SUBDIVISION REPORT

S/D NO. 78-103 Name Campus Valley Addition
Date Application Rec'd. 12-18-78 Preliminary Approval 12-28-78
Scheduled S/D Meeting 2-21-80

PROJECT: Campus Valley
Drainage Plan

SUBJECT Campus Valley Addition/Drainage Plan

CAMPUS VALLEY ADDITION
DRAINAGE AREAS

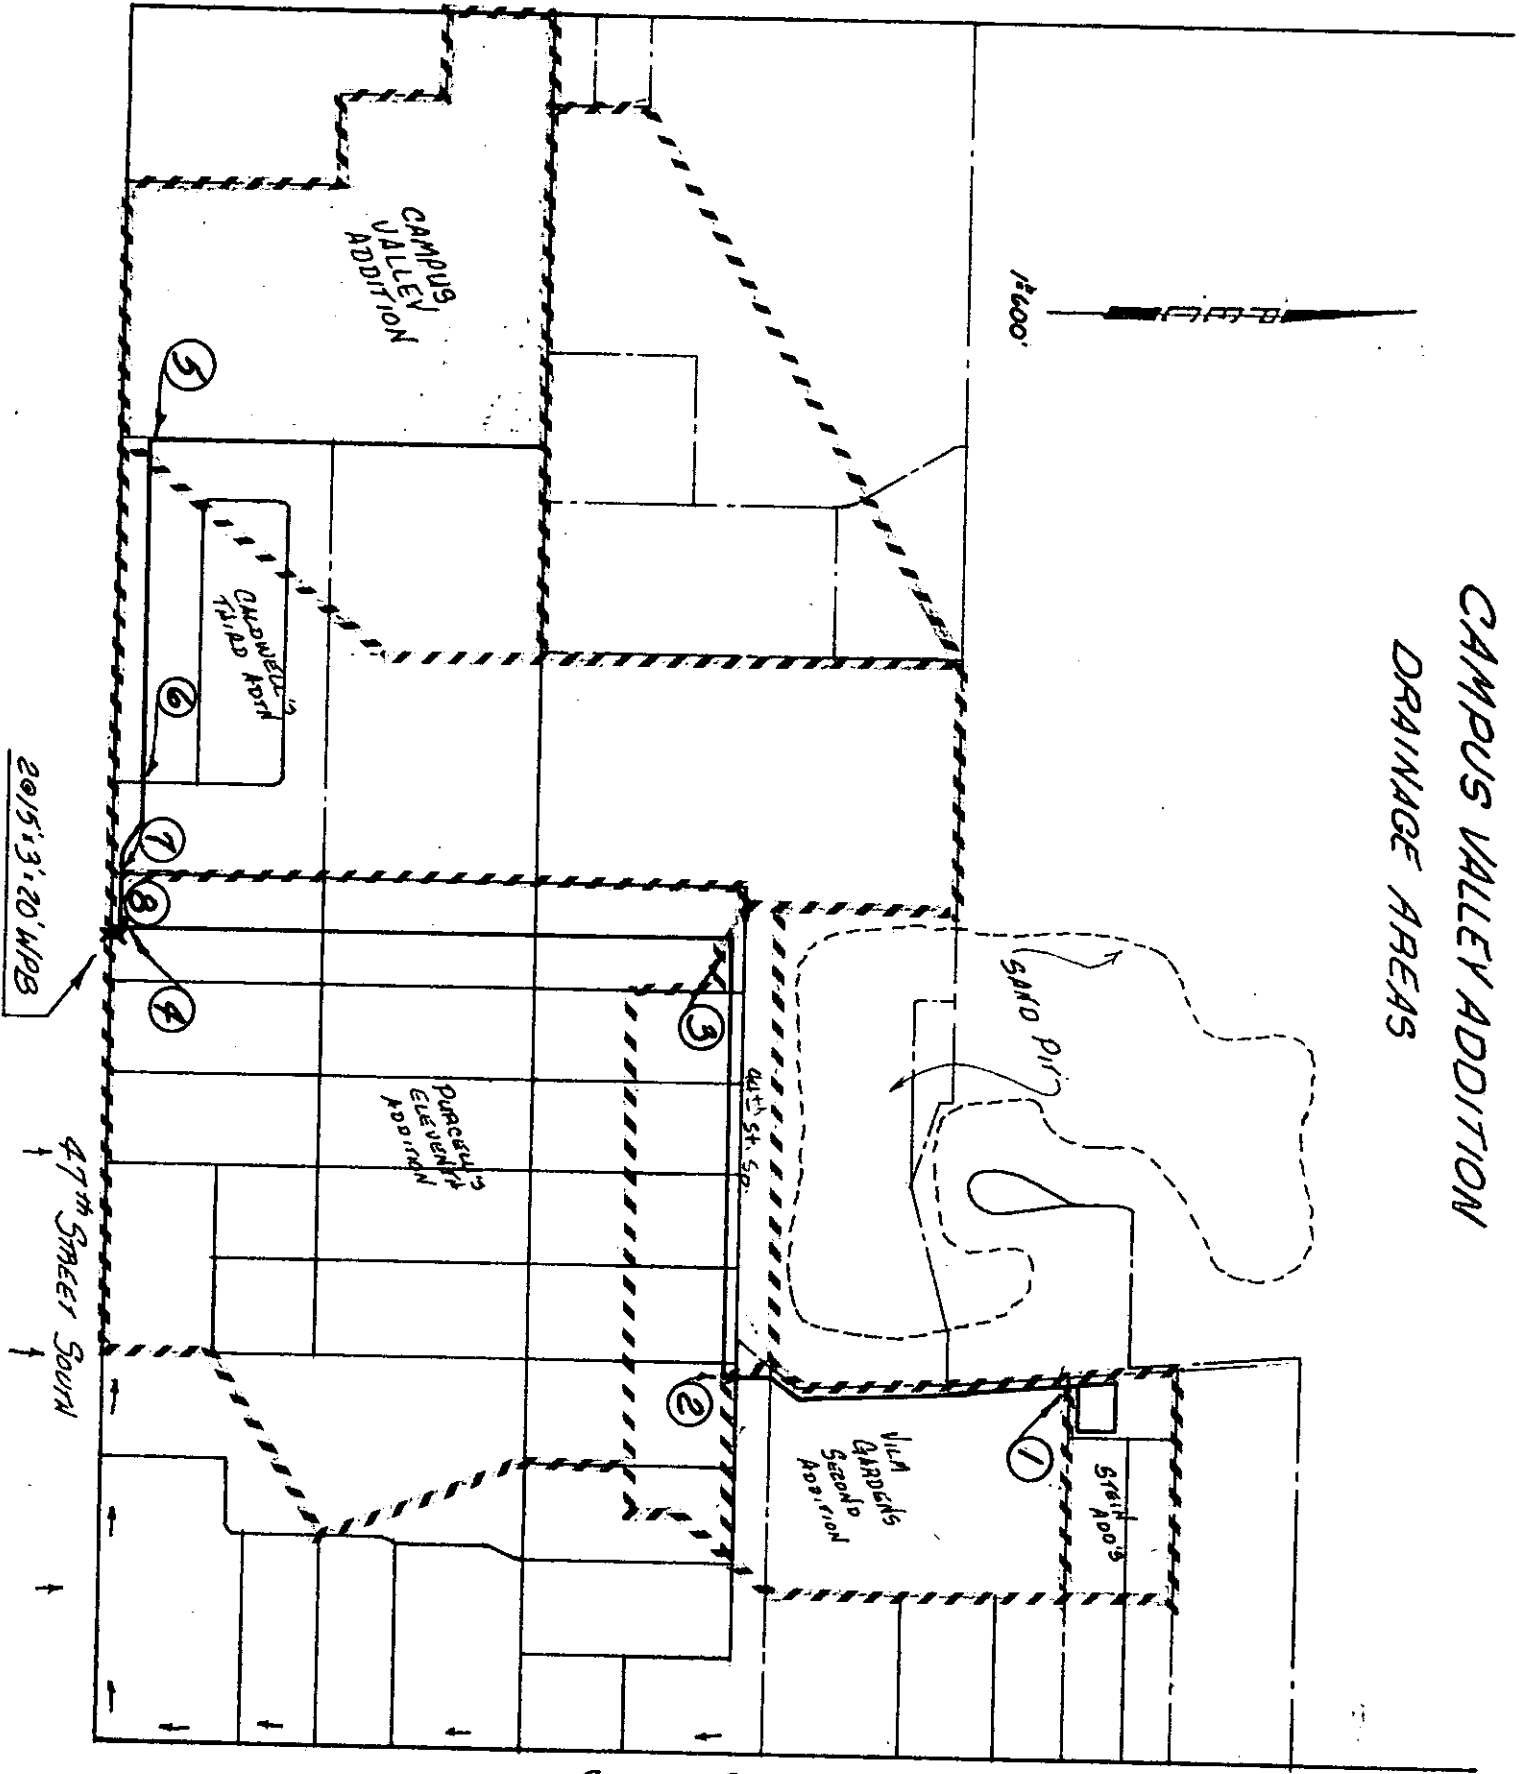
The calculations submitted by the consultant indicate that the geometry of the channel downstream from the 47th Street South does not have the capacity to handle the runoff generated by the two year frequency rainfall over both Caldwell's 3rd Addition and proposed Campus Valley Addition. The City of Wichita criteria specifies that the channel downstream handle 100 year frequency runoff from the total drainage basin, upstream from the 47th Street South bridge (approximately 650 acres). Under the circumstances, detention would be the only method of development for this plat. However, consideration is given by the Flood Control Office to the drainage plan submitted by the consultant recommending installation of a larger structure under 47th Street South to pass the runoff generated by the 216 acre sub-basin comprising of Campus Valley Addition, thus nullifying its flood influence in Purcell's 11th Addition. Since the calculations submitted by the consultant does not include a backwater curve based on existing geometry of the channel and structures downstream from 47th Street South, the analysis fails to show the flood effect of improving this subdivision on Purcell's 11th Addition.

Based upon the data submitted to date with the drainage plan by the consultant and the letter by the Flood Control Division, approval of the plat is at the discretion of the Flood Control Engineer.

Based on such approval by the Flood Control Office, this office agrees that the developers of Campus Valley Addition shall guarantee construction of the proposed channel and the structure under 47th Street South. The proposed channel includes the portion along South Line of the Caldwell's 3rd Addition Plat. The developer also agrees to guarantee construction of necessary storm sewers to drain the Campus Valley Addition to the proposed channel.

Letter (6/12/79) & study (6/11/79) of Campus Valley
Drainage Plan by PEC

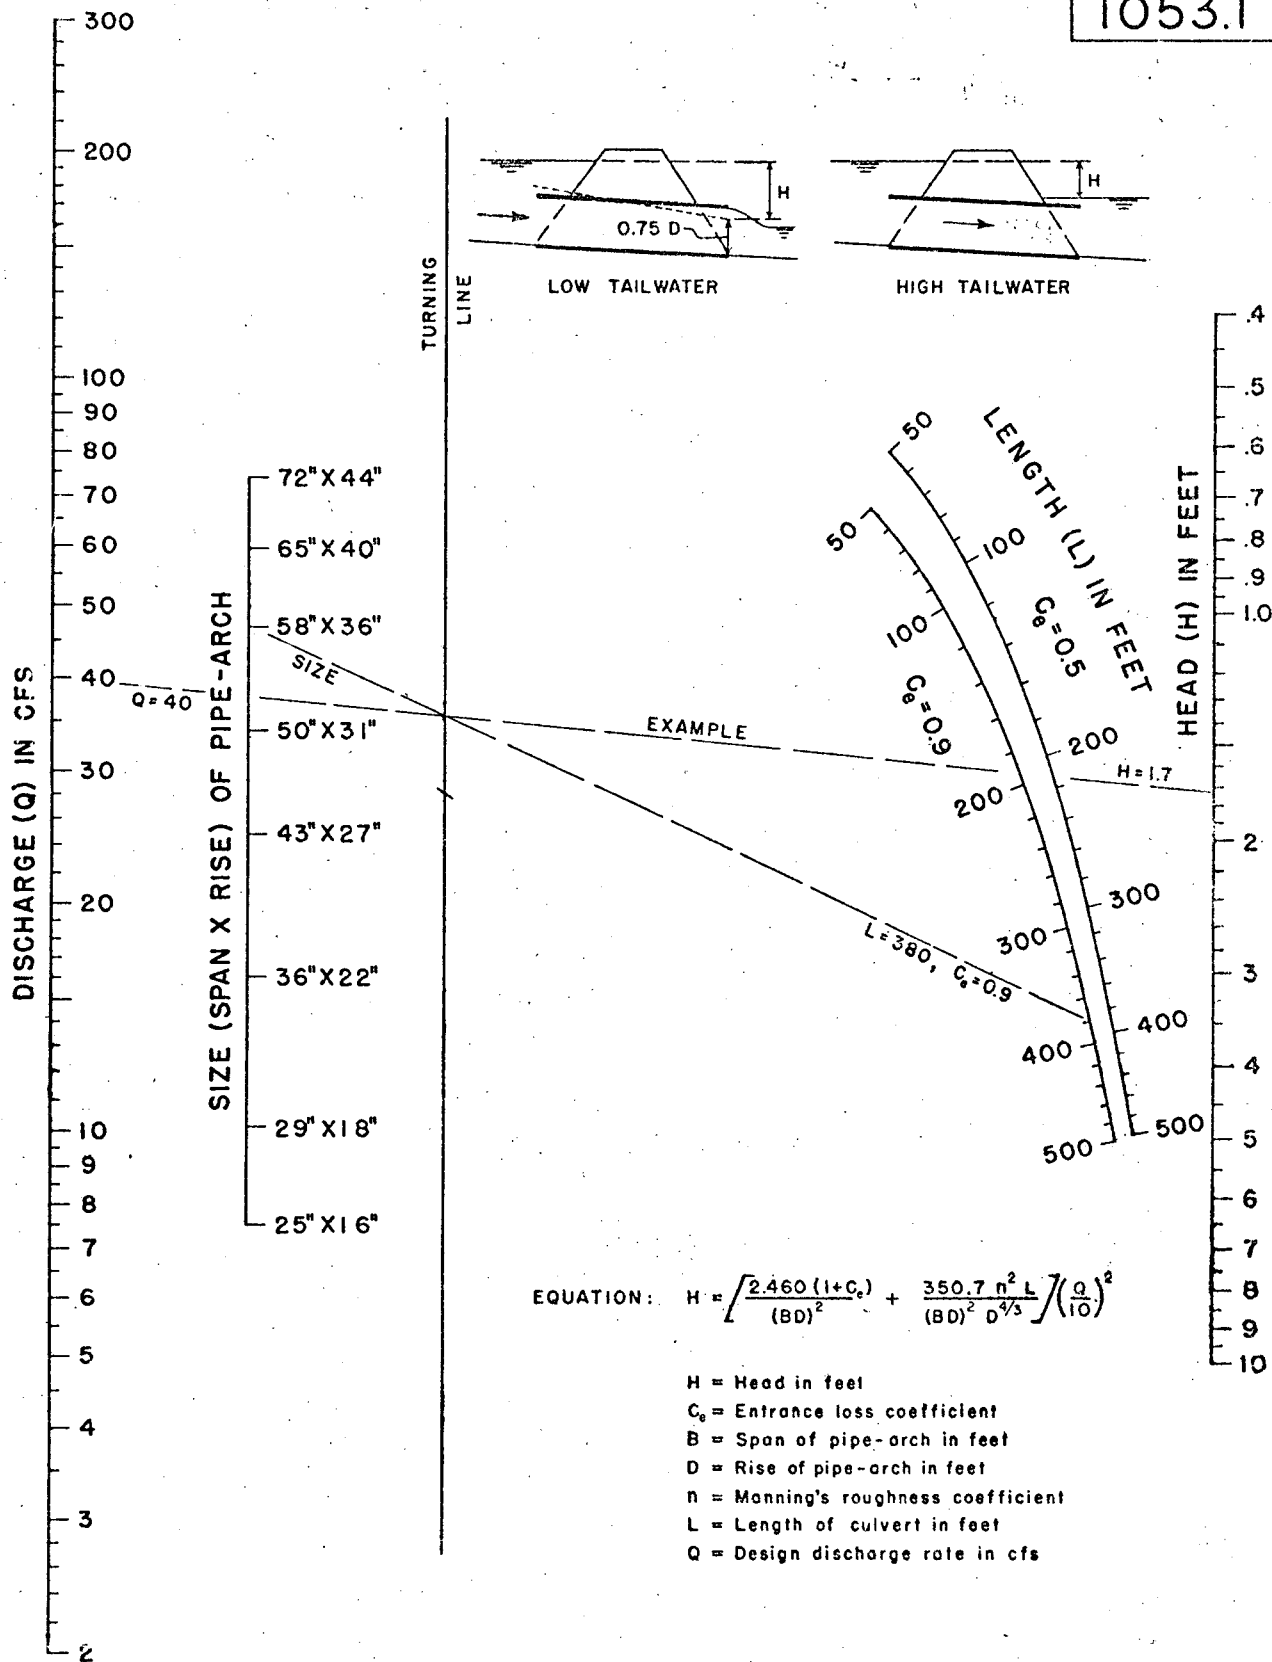
Bridge Existing	Bridge New	2-49"x33"
DSWS	85.48	85.71	85.71
USWS	86.25	85.97	89.11
Q	216 cfs	135 cfs	119 cfs

Flows over 47th St @ 88⁵/₁₆

Determine max. permissible water
surface @ NW of 47th St & Clarence
and then determine conduit required
for 119 cfs & the water surfaces.
